RE: Resource Planning and Procurement in 2011 and 2012 – Docket No.
E-00000A-11-0113

Comments of the Interstate Renewable Energy Council on Integrated Resource Planning,
Docket No. E-00000A-11-0113

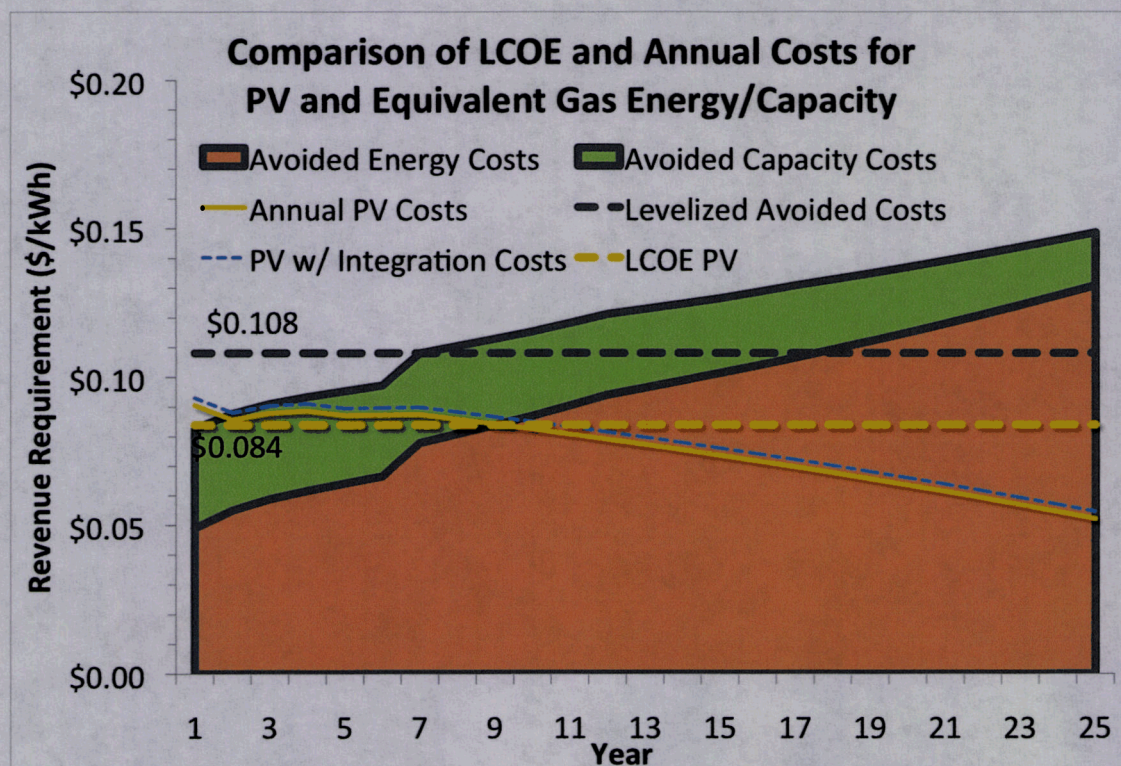
10. The alternative scenarios evaluated in APS' IRP are insufficiently distinct from the Base Case

The annual revenue requirements in each of the four scenarios presented by APS are largely similar. The net present value revenue requirement (2012-2027) for each of the

three alternatives scenarios ranged from an increase above the base case of as little as 1 percent to as much as 4 percent. With such little variation between the scenarios it is difficult to distinguish the true impact of resource choices on costs over the long term. Since the IRP does not dictate procurement it would helpful to stakeholders for APS to explore additional scenarios that are perhaps less plausible, and not intended to be implemented, but are intended to illustrate more starkly the impact resource choices have on future costs and other outcomes. For example, one could envision a hypothetical "all renewables" case or an "all gas" case. Furthermore, an "enhanced EE" scenario would be a logical complement to the existing "enhanced RE" scenario. Additionally, a "high distributed energy" scenario would be illustrative for the costs and benefits of growing the customer-generation fraction of the resource portfolio.
